DESIGN A	DRAWN BY B	DART AEROSPACE LTD HAWKESBURY, ONTARIO, CANADA	
CHECKED LE	APPROVED A	DRAWING NO. DSI 9273	REV. B SHEET 1 OF 1
DATE 07.05.30		TITLE ADD D350-607-045	SCALE NTS
A	04.02.02	NEW ISSUE	
B	07.05.30	CORRECTED TYPO ON CERT NUMBER

DART SERVICE INSTRUCTION

TO AMEND INSTALLATION DRAWING D350-607 REV. F

REF. CANADIAN STC: SH94-14

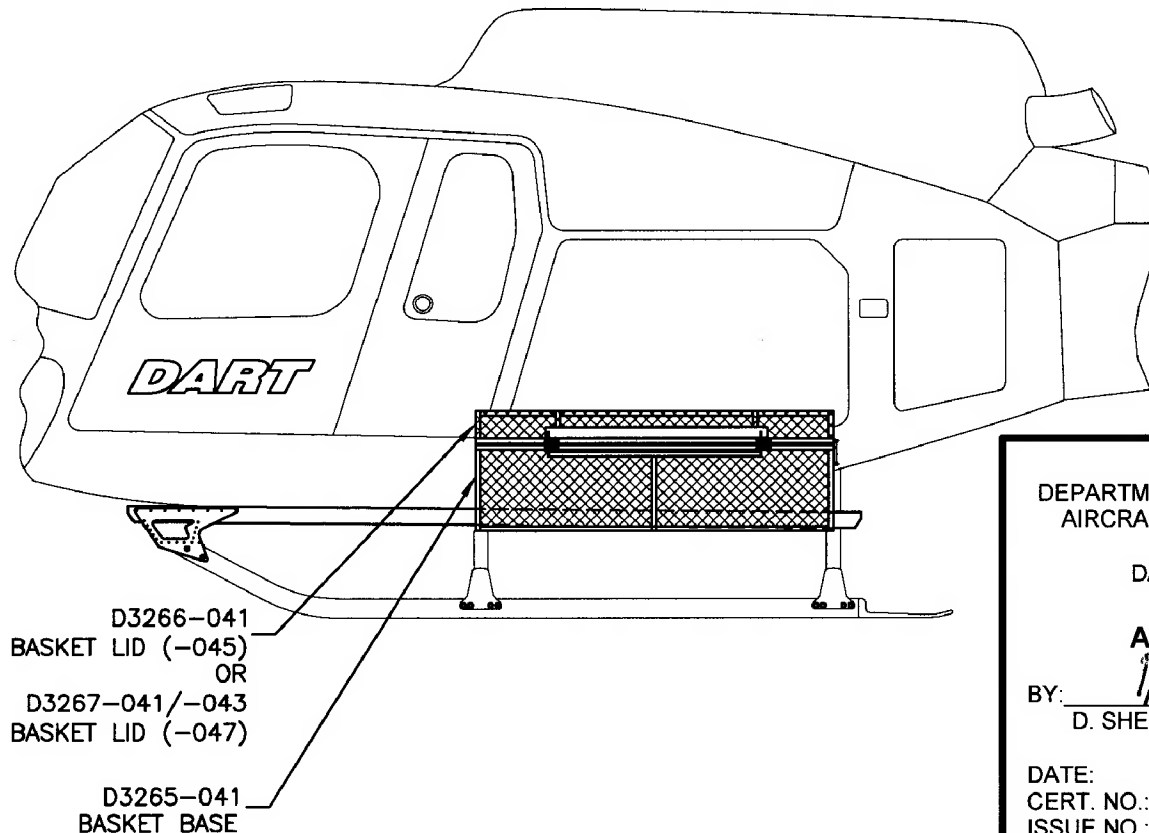
Add D350-607-045 and D350-607-047 to D350-607 Rev.F. Install and maintain D350-607-045/-047 the same as D350-607-041/-043. Parts list for D350-607-045 is same as D350-607-041, except that D3265-041 Base replaces D2221 Base and D3266-041 Lid replaces D2512 Lid. Parts list for the D350-607-047 is the same as D350-607-043 except that D3265-041 Base replaces D2221 Base and D3267-041/-043 Lid replaces D2989-041/-043 Lid. Weight & balance for D350-607-045/-047 is as follows:

Installation	Weight	Lateral		Longitudinal	
		Arm	Moment	Arm	Moment
D350-607-045 <i>Heli-Utility-Basket™</i>	65.0 lb 29.5 kg	±48 in ±1.22 m	±3120 in-lb ±36.0 m-kg	135 in 3.43 m	8775 in-lb 101.2 m-kg
D350-607-047 <i>Heli-Utility-Basket™</i>	65.0 lb 29.5 kg	±48 in ±1.22 m	±3120 in-lb ±36.0 m-kg	135 in 3.43 m	8775 in-lb 101.2 m-kg
